Concerning Part Name: MICC & MICC/N Series

Product Type: Leaded Inductor {Radial}

Classification of Change: Mechanical

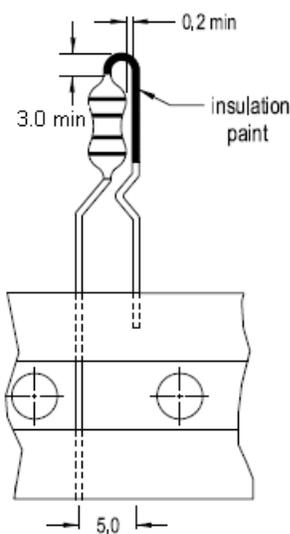
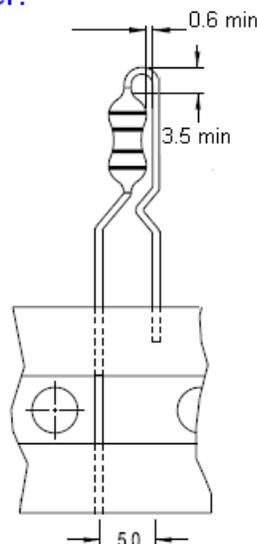
Description of Change: To eliminate the insulation paint on the bent upper lead and change the spacing between the lead and the coil body from 0.2 mm min to 0.6 mm min.
